TOWN OF NORTH CASTLE

RPRC DETERMINATION LETTER

Project Description:	Pool
Street Location:	24 WINDMILL PL
	Zoning District: R-4A Tax ID: 102.01-1-17 Application No.: 2021-0283
RPRC DECISION:	RPRC - Submit to Building Department
Date:	04/20/2021

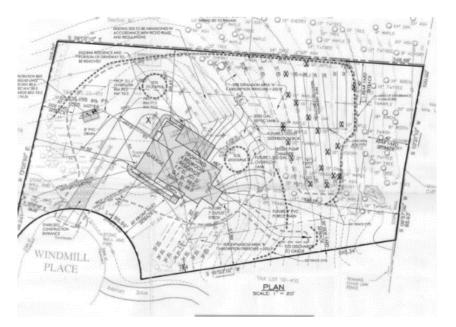
- The site plan shall be revised to depict proposed evergreen screening along the rear lot line to screen the house and pool activity area.
- The site plan should be revised to label the lot lines as depicted on the site plan for the construction of the house (below). In addition, the building envelope as depicted on the site plan below should also be depicted on the site plan. A zoning conformance plan should be added to the site plan. It is not clear whether the proposed pool complex meets the minimum required yard setbacks.
